Access Compliance Report

Public Rights-of-Way (Curb Ramps)

Intersection ID: 52448	Main Street: WOODWARD_AV	Cross Street: DOUBLE_OAKS_RD	Location: SE
ADA ID: AEE66F0F6CC5	Ramp Type: Directional1	Initial Pass/Fail: Pass	Overall Compliance: No
Severity Score: 15.25			
Codes/Mitigation Info/Possible Solution		Field Measurements/Component Compliance

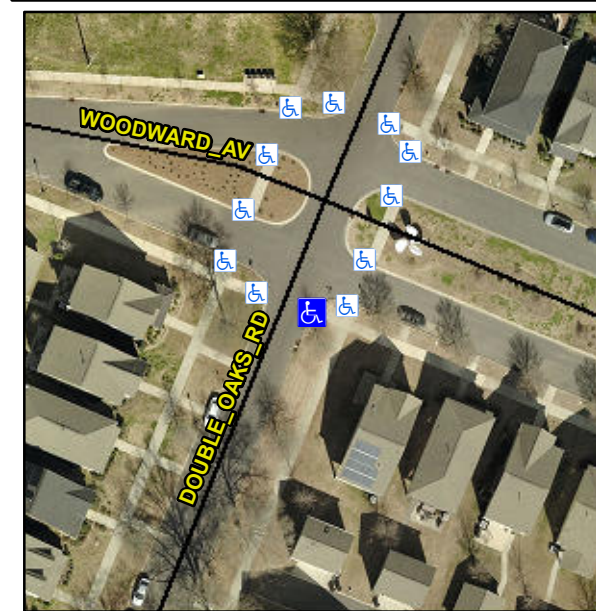
**Remove & Replace Entire Ramp.
Grind Gutter Lip.**

R304.5.3, R302.7.2
